# HARRISVILLE CITY

## Harrisville City Planning Commission Harrisville City Offices Wednesday, July 10, 2024

### AGENDA

TO: Harrisville City Planning Commission  
FROM: Matt Robertson, City Engineer  
**RE: HEAVENLY ROADS SUBDIVISION  
Preliminary Plat Submittal**  
Date: July 3, 2024

SITE & UTILITY PLAN FOR

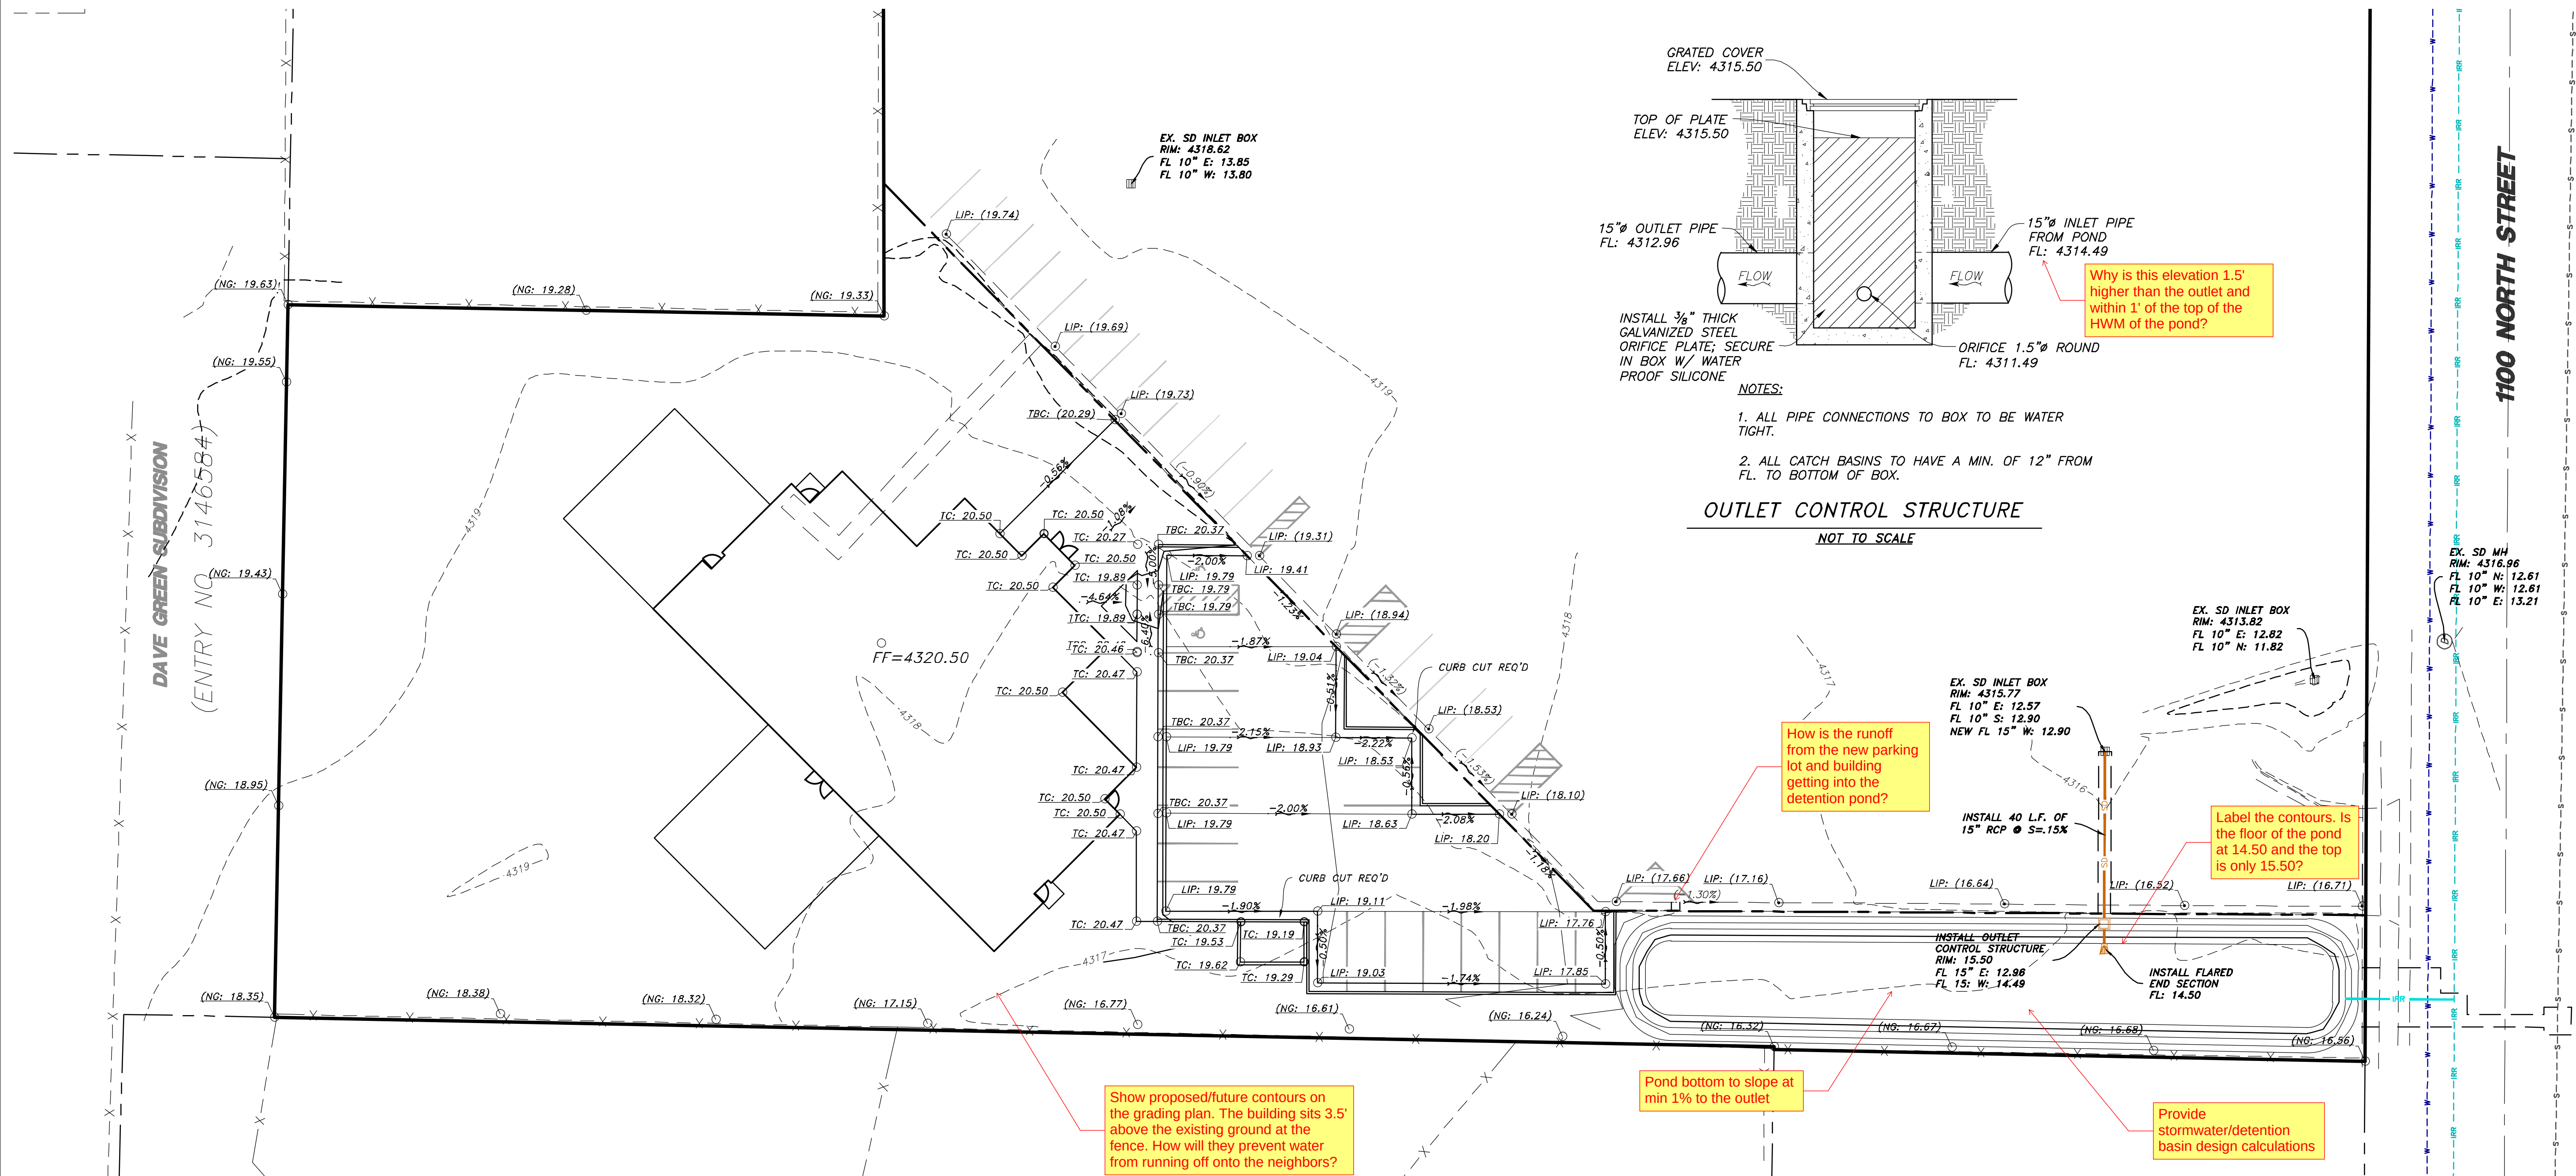
3. Provide a landscape plan for the new site.
4. Update the sewer plan to show a 4" sewer lateral being run from the building if the sewer elevation can be raised at the building. The 4" lateral should connect to the main without a manhole. See red-line comments on the plans.

6. Remove the striping of existing parking stalls at the entrances to the new parking lot.
7. Show the proposed contours on the grading plan and show how runoff will be kept on the site and not flow onto the neighboring properties to the west, particularly near the southwest corner of the new building.

8. Show how the parking lot runoff will be directed to the detention basin and make sure that the floor of the detention basin has a minimum 1% slope to the outlet.

9. Show the detention basin calculations and clarify the elevations of the outlet pipe and the elevations of the basin bottom and top.
10. Provide screening between the commercial zone per Section 11.13.050 of the City Code.
